AGENDA

4. Recommendation to review and approve the 140 West 2nd Design Review Application P24-092.
ADJOURNMENT:

The applicant is proposing to develop a new 9,363-gross-square-foot mixed-use building located at 140 W 2nd Street (the “subject property”) in the Mixed-Use Subdistrict of the Community Core (“CC-2 Zone”). The project includes an art gallery and showroom space on the ground level, two multi-family dwelling units on the second floor, and a residential penthouse on the third floor (see Figure 1). Four

DEMOLITION PLAN
140 W 2ND STREET KETCHUM, ID
 PREPARED FOR: BILL GRIFFIN
 PROJECT NUMBER: 24022
 SCALE: C0.90

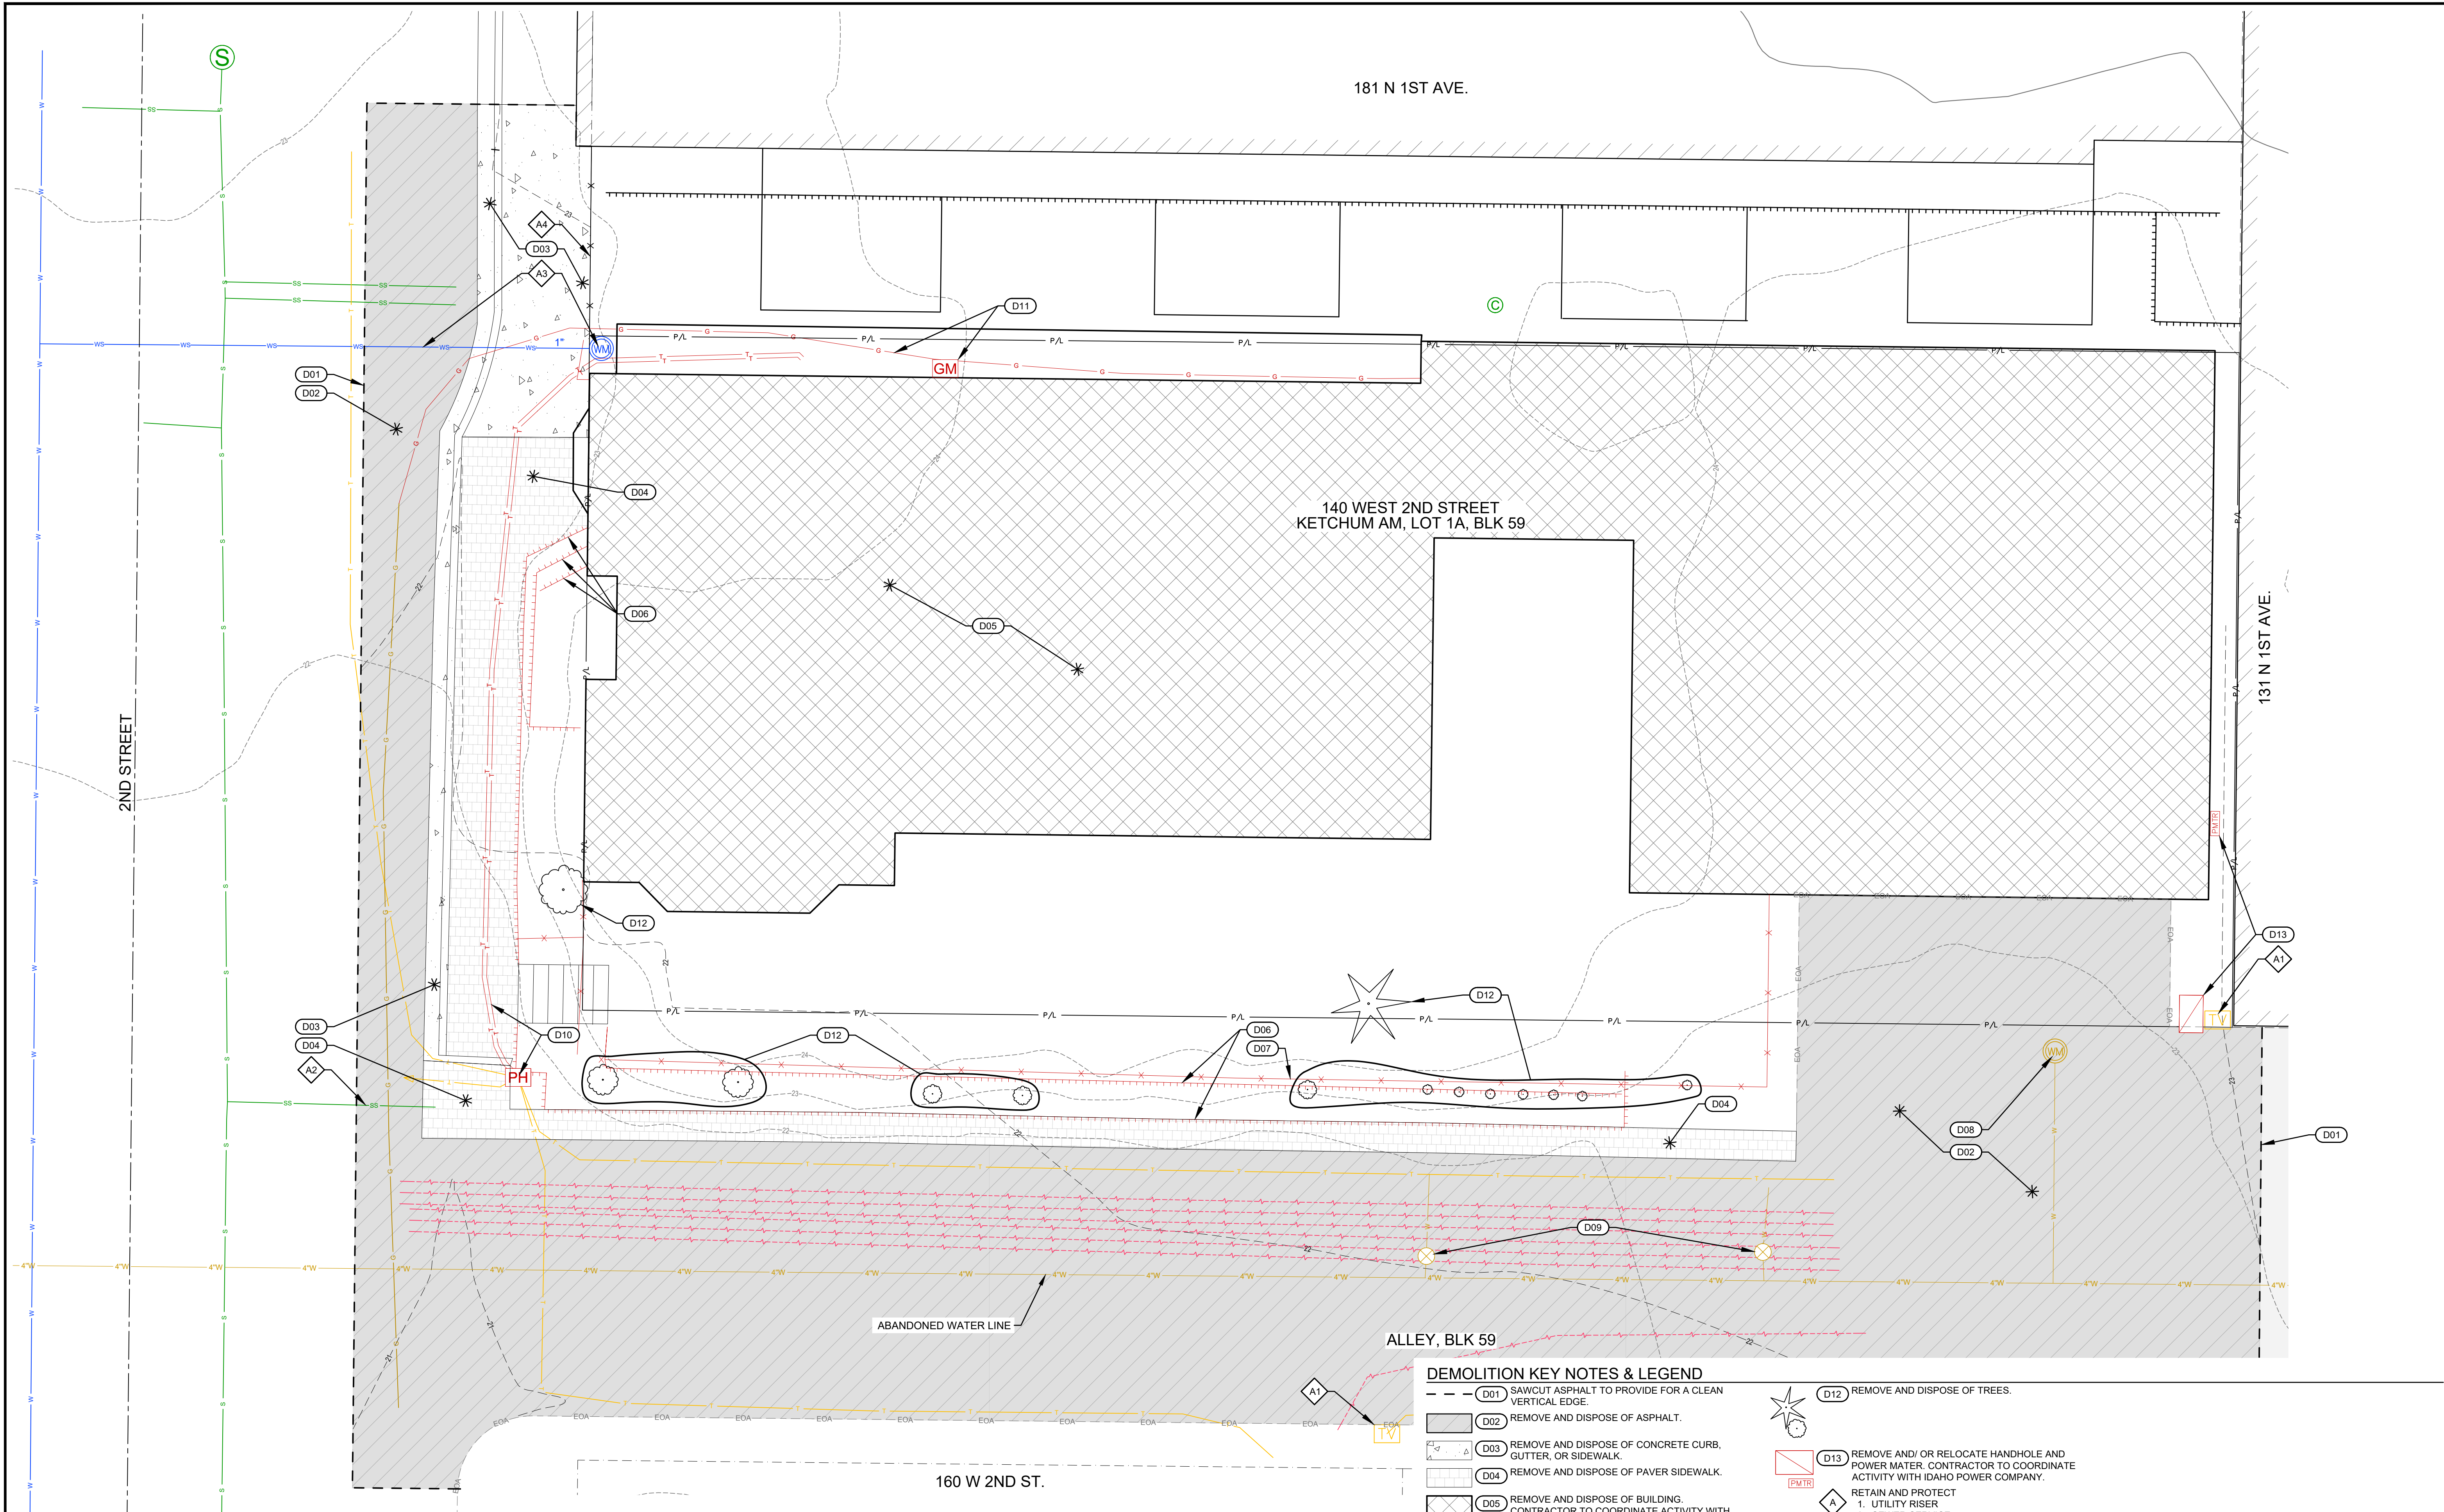
Finding: The demolition plan on sheet C0.90 shows one tree that is proposed to be removed from the subject property. All other trees proposed to be removed are within the adjacent public right-of-way along the alley. The Weeping Norway spruce trees shown on the landscape plan satisfy the replacement tree requirement.
